**Examining Authority’s Issue Specific Hearing 2 (ISH2) Wednesday 28 to Friday 30 January 2026 Supplementary agenda additional questions**

In response to the Examination Authority’s Action Points arising from Issue Specific Hearing 2 (ISH2) on 29<sup>th</sup> January 2026 the MCA would like to comment as follows at Deadline 4, Tuesday 10 February 2026.

**Fig.1- MCA RAM & Restricted Visibility Stop SimOps Area**

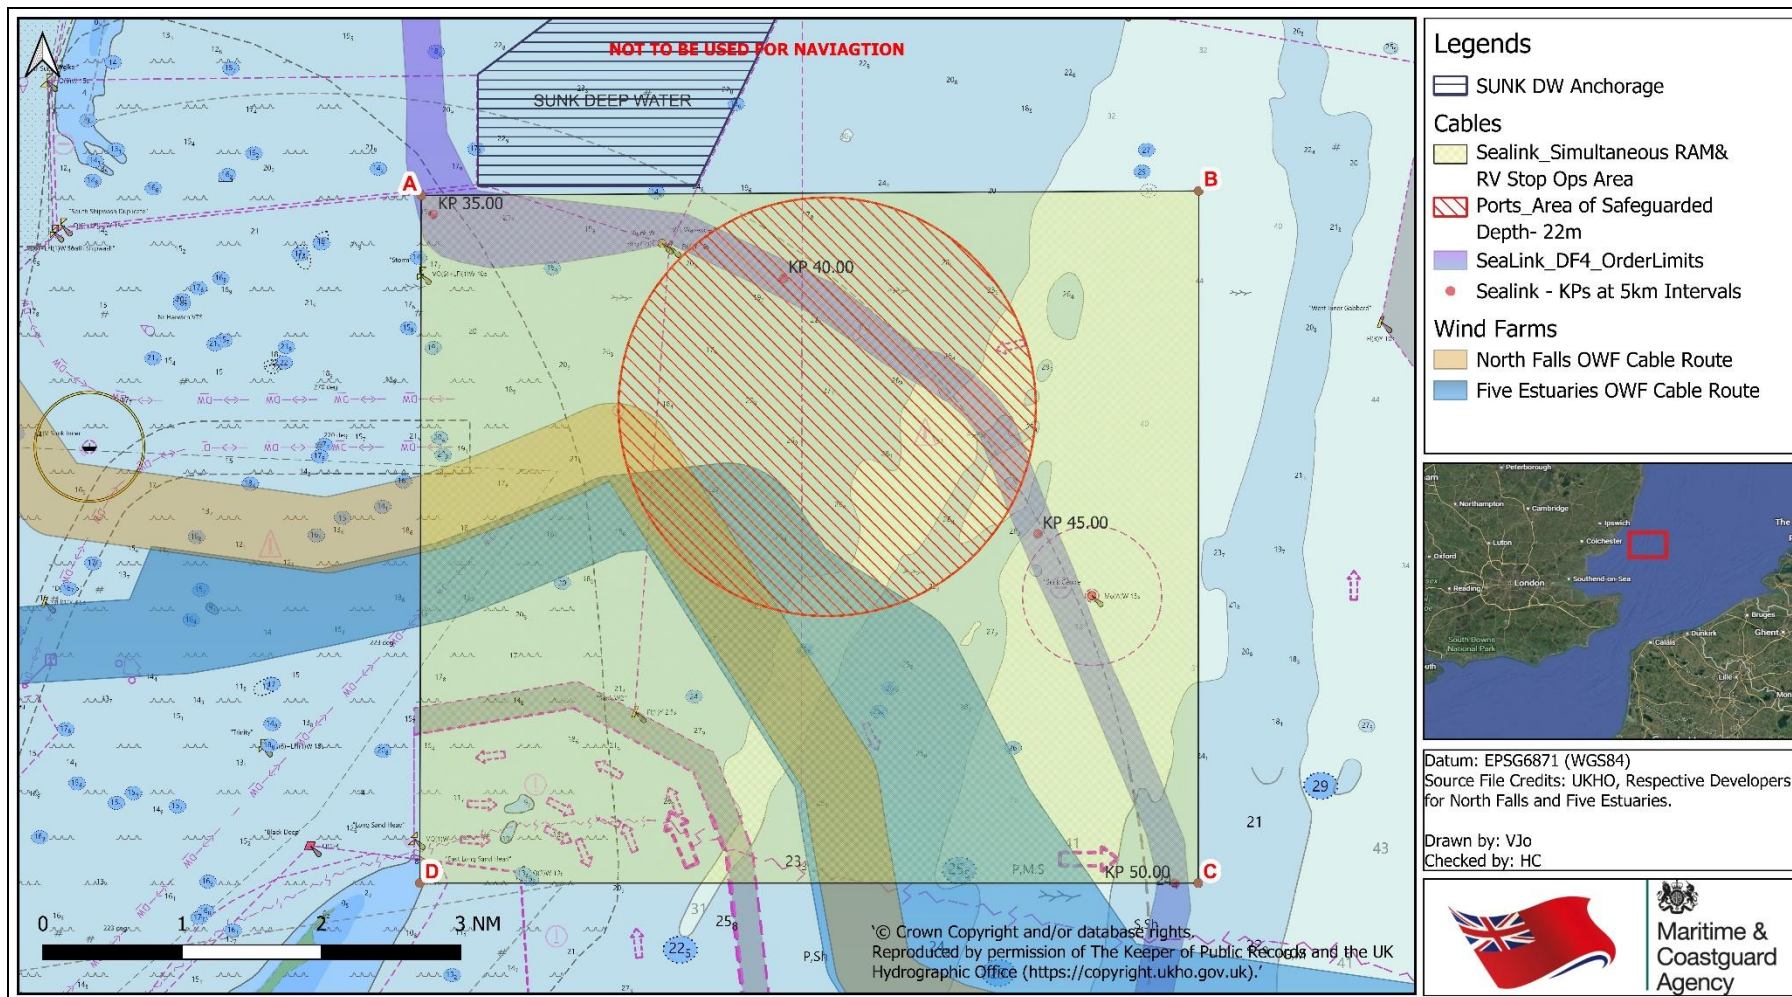
| 98. | MCA to provide the applicant with an updated defined area for the avoidance of concurrent restricted ability to manoeuvre activities and restriction on activities when visibility is poor in relation to Sea Link activities.   | MCA                      | DL4 | <p>As the National Competent Authority for the SUNK Vessel Traffic Services (VTS), the MCA requests that our defined area of interest (<b>figure 1</b> below) for Sea Link to commit to no concurrent activities with other projects <u>and</u> for Sea Link to cease operations in visibility of less than 2nm, is secured in the DCO DML as this is a key risk mitigation measure to preserve the safety of navigation in the SUNK area.</p> <p>Specifically:</p> <ol style="list-style-type: none"> <li>1) No Sea Link project activities involving vessels Restricted in Ability to Manoeuvre (RAM) to operate concurrently with activities involving RAM vessels planned by the Five Estuaries and North Falls offshore windfarm project in the SUNK area (or</li> </ol>  |

- 2) No Sea Link project vessels with Restricted Ability to Manoeuvre (RAM) (cable laying, UXO clearance, survey) are to operate when visibility is below 2 nautical miles within the MCA's defined area in **figure 1**.

- 1) The defined area of interest in **figure 1** is a relatively small area of navigable sea room considering the size and draft of the vessels involved. Pilot boarding/dis-embarking is an 'area' and not a specific point. Vessels are usually requested to come to a position 1NM to the east of the pilot boarding area or 1.5 northeast for the ultra-large vessels. The vessels are then given a heading to board which could be any heading based on the weather / sea conditions. As such, vessels are boarded anywhere to the east of a line drawn North-South through the pilot diamond, including in the anchorages. The same applies to vessels disembarking a pilot which could be anywhere in (or close) to one of the Deep-Water Routes in the Sunk Inner.

|  |  |  |  | <p>2) Additionally, the MCA is requesting a larger defined area of interest <b>figure 1</b> than was previously permitted for the North Falls &amp; Five Estuaries projects. When those projects were approved, both were located to the south of the area, which still left a small section of navigable sea room to the north for other activities. However, the Sea Link project now occupies the northern part of the area significantly reducing the remaining safe sea room and further limiting the ability to conduct marine operations or transits to and from PLA and HHA.</p> <p>3) This is further compounded as almost all vessels exit the Sunk Inner to the Southeast to follow the IMO routing measure in the Strait of Dover which is considered as one of the busiest and most complex shipping lanes in the world. If all three project operations were taking place at the same time, the southeast corridor would be reduced to less than 1NM wide.</p> <p>4) Also, a recent trend is that, due to the northward migration of the Long Sand bank (within the SUNK area), the larger vessels using the Long Sand Head two-way route increasingly tend to divert into the Sunk Inner (north of the magenta line marking the northern limit of the LSH route), to maintain safe navigable depth. This behaviour further reduces available sea room particularly when vessels are simultaneously outbound from the PLA or HHA and can therefore create additional navigational constraints. This can be seen in <b>Figure 3</b> attached below, sourced from applicants' submission APP-284- Fig. 6.4.4.7.4.14.</p> |

Fig.2- MCA Depth areas of Interest

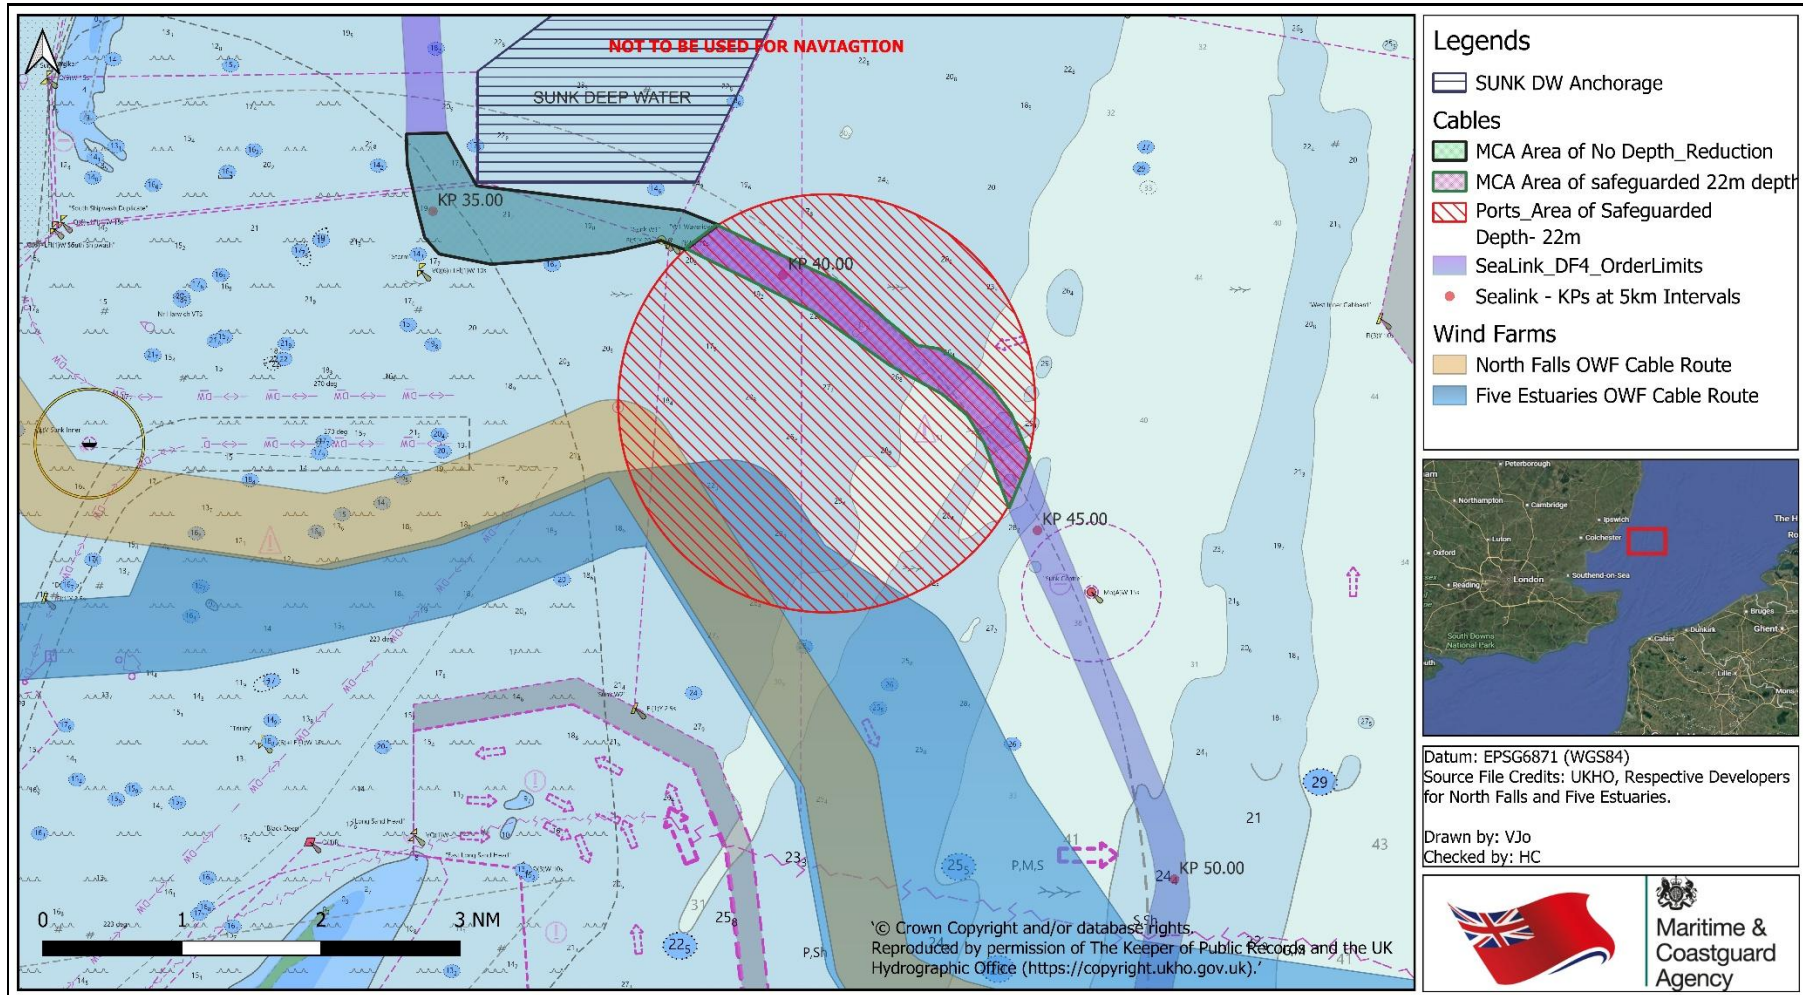
|  |  |  | <p>The four significant areas of interest for MCA are as follows:</p> <ol style="list-style-type: none"><li>1) <b>Safeguarding navigable depth and preventing anchor strikes by deep draught vessels in the vicinity the SUNK DW anchorage.</b> See <b>figure 2</b> below. This area is between KP 33 and KP 38, we are aiming for no depth reduction, adequate burial as per recommended Depth of Lowering in the Cable Burial Risk Assessment, including any potential anchor interaction with associated protection measures. Where this is not achievable, further discussion is required on the application of the 5% depth reduction as per current DCO DML condition.</li><li>2) <b>Securing the 22m safe guarded depth</b> for future dredging as agreed with the ports. See <b>figure 2</b> below. This area is between KP 38 and KP 44, we fully support the Port's requirement for the cable (and any covering material e.g. rock armour) to be <u>at least 22 metres</u> below Chart Datum in the vicinity of the Deep-Water (DW) Route and DW Anchorage to allow future vessels with a draught of 20 metres. The MCA would expect a post-lay cable burial survey to be carried out to confirm where the target depths have or have not been met and secured in the DCO.</li></ol> <p>It is the MCA's view that the requirement for a post-lay cable burial survey (to confirm the target has been met) <u>is</u> suitably secured in the DCO DML part 2 Schedule 16 Conditions 14, which states:</p> |
